SUBJECT: Stamping of all L Model  
Registering and Counting  
Dial Shafts

DATE: January 17, 1935

TO ALL OFFICES:

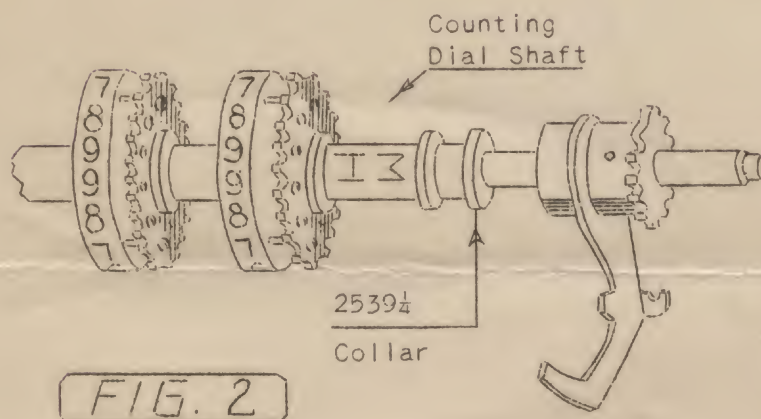
To assist servicemen in making replacements we are now identifying all L Model registering and counting dial shafts with stamped letters on the R.H. end collars which designates whether the alignments of the collars and dials are high, medium or low. The L.H. letter on the 2547 1/4 collar pertains to the dials and the R.H. letter on this collar refers to the collars. See figure 1. The upper letter on the 2539 1/4 collar pertains to the collars and the lower letter refers to the dials. See figures 2 and 3.

High, medium, and low dials and collars may be requisitioned for replacement purposes by prefixing the part or assembly number with H, M, and L.

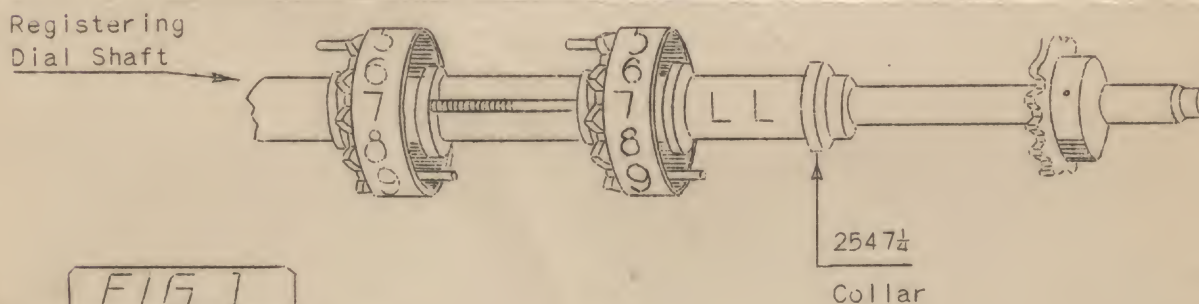
To read letters on the 2539 1/4 collar, hold the counting dial shaft as shown in figure 3.
